Service Bulletin

S.B. No: 187

Title: INSPECTION FOR CLEARANCE BETWEEN RUDDER PEDAL AND MIXTURE/PROP. SPEED BRACKET AND FOR GROUND TOWING DAMAGE. ALSO INCLUDES GENERAL RUDDER PEDAL CLEARANCES.

Applicability: T67M200 (Works No. 2264 & 2265 only), T67M260 and T67M260-T3A.

FIGURE 12

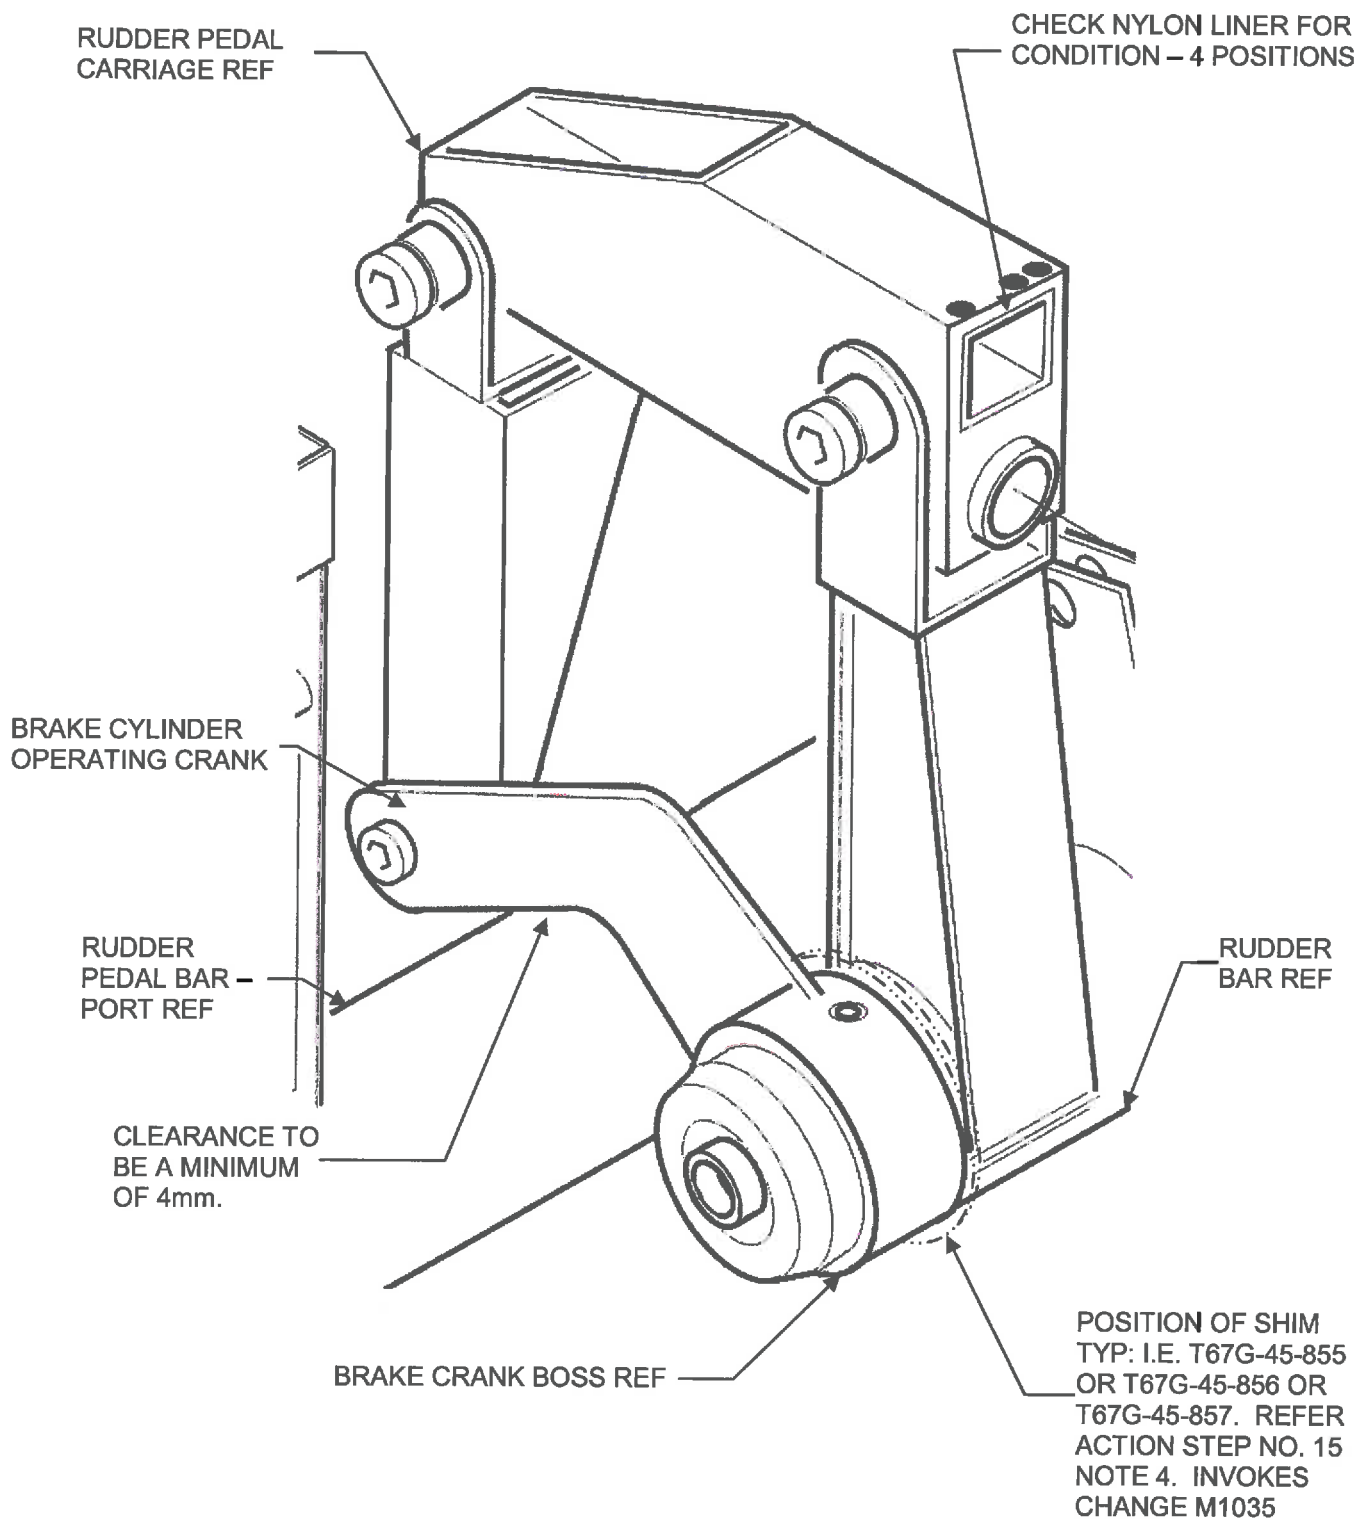
Note 4: To further ensure clearances are achieved it is acceptable to shim between brake crank boss and rudder bar, as indicated by Figure 12. There are 3 thicknesses of shim available: 0.5mm, 1.0mm and 1.3mm, part numbers T67G-45-855, T67G-45-856 and T67G-45-857 respectively. The fitment of these shims invokes Change Mod M1035 "Introduction of Shim between Brake Crank Boss and Rudder Bar".

32. Ensure that the brake operating crank, as shown at Figure 12, has a minimum clearance of 4mm relative to the rudder pedal bar following all checks and rectifications. Allow for various brake conditions, refer paragraph 33.2. Should bar show signs of chaffing check depth of groove. If depth is 0.0mm to 0.5mm, remove rudder bar, blend out groove, repaint and refit. If the groove is to a depth greater than 0.5mm, remove rudder bar and return to MSAC for repair or replacement.

FIGURE 13A
SECTION 'F-F' (REFER FIGURE 4)

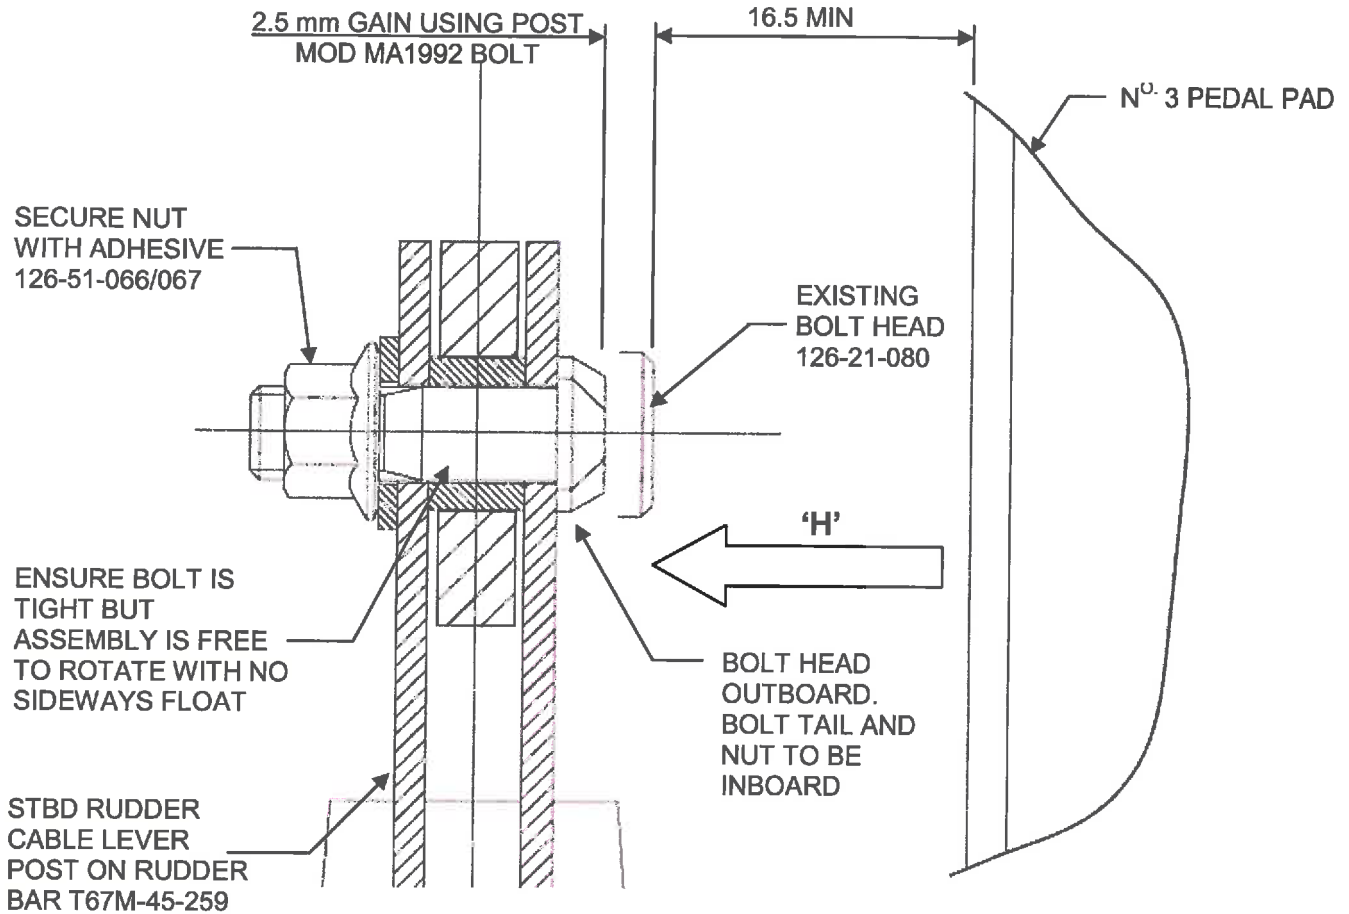
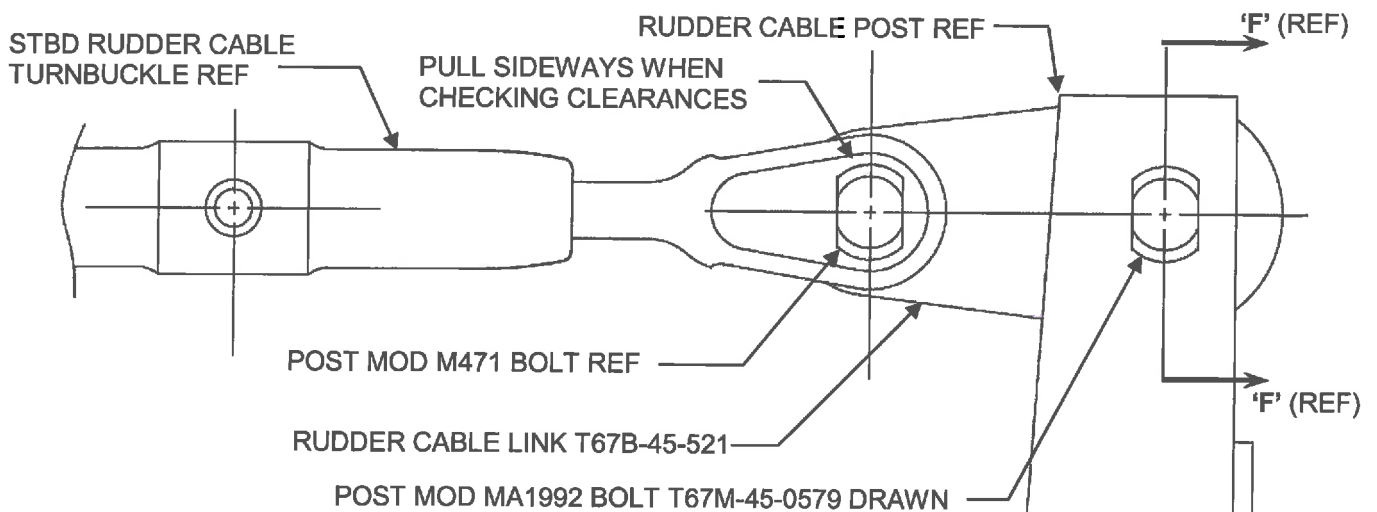
1. (a) Referring to Figures 4, 13A and 13B, check the Right Hand pilot's left pedal (Pedal No. 3) for clearances from: i) starboard rudder cable attachment bolts to link plate and ii) link plate to rudder bar lever post. Clearances should be a minimum of 15mm and 16.5mm respectively. Clearance checks to be performed at all four pedal adjusted positions, but especially; with pedal adjusted fully forward (or past last adjustment position), with full left rudder applied, together with a left hand side force applied to the pedal – refer Figure 4 – and that any slack in the rudder cable is taken up in the starboard direction - see notes below.

Note 2: ensure there is no end float in the bolts, i.e. that they are tight but not tight enough to restrict rotation. Ensure Loctite is applied to stiffnut after adjustment or replacement, MSAC code 126-51-066 or 067, Figure 13A Section F-F refers.

Note 3: if clearance of 16.5mm cannot be achieved then fit special low head bolt T67M-45-0579 thus invoking Mod MA1992. Mod kit T67A-05-1992 to be obtained from MSAC Product Support.

FIGURE 17

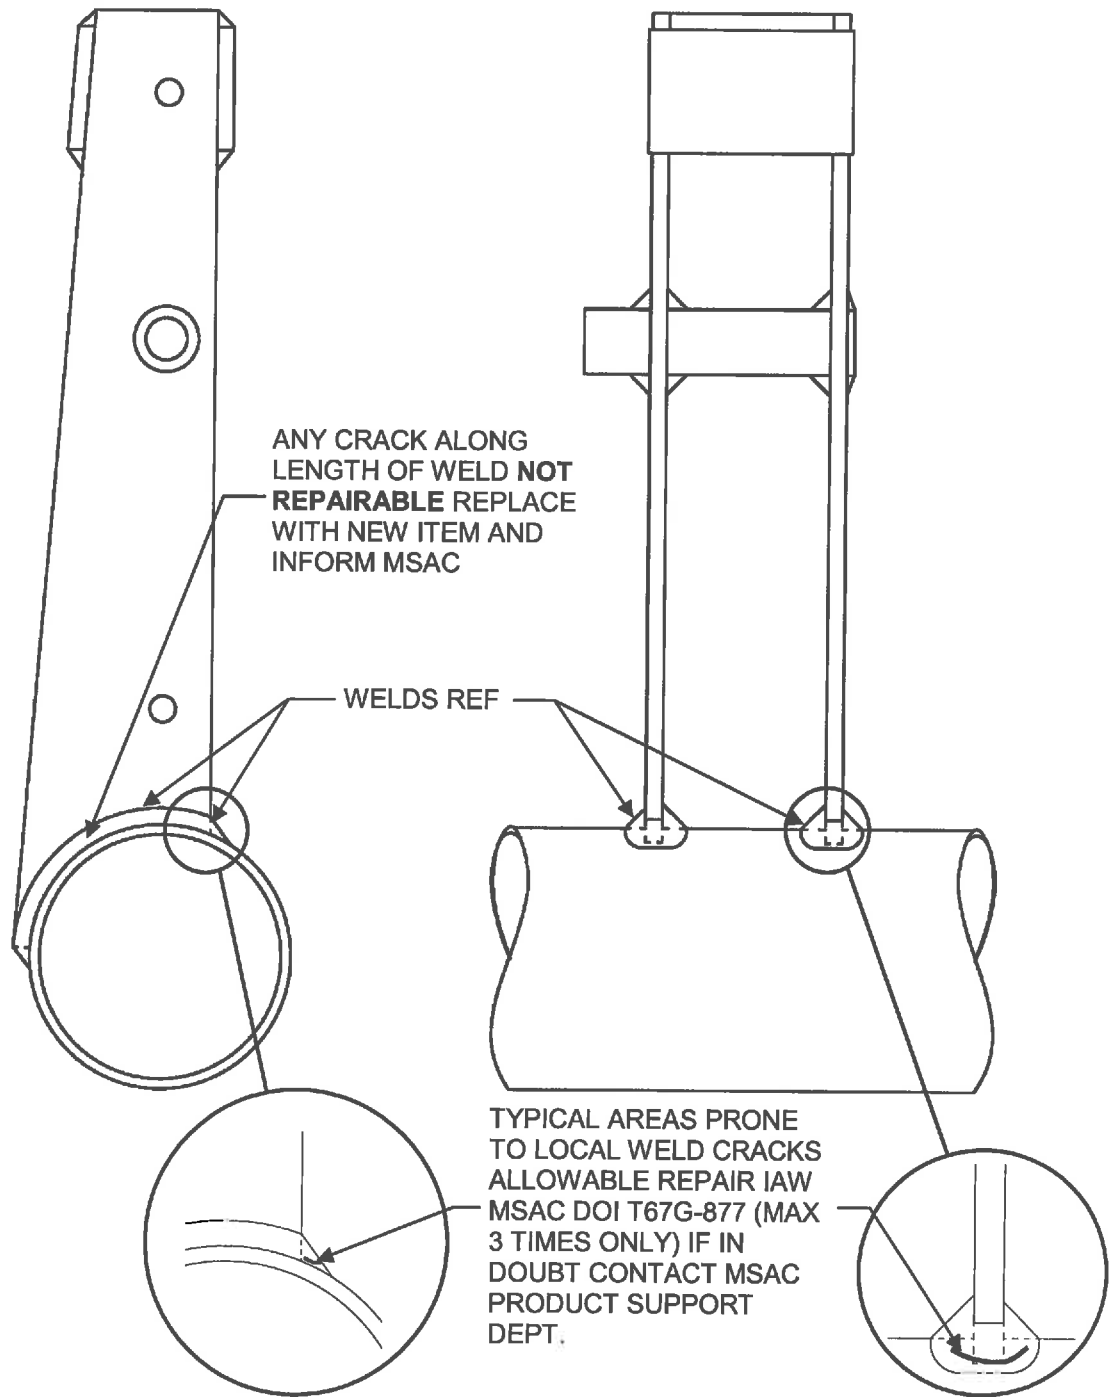
Note rudder bars may have minor cracks in the welds at the bases of the various lever positions Figure 17 refers. This is a known condition and can be returned to MSAC for repair or repaired IAW with DOI T67G-877 latest issue. Note each individual crack can only be repaired up to a maximum of 3 times. Record to be kept of weld repairs. Replacement bars T67M-45-257 and T67M-45-259 are available from MSAC product support.
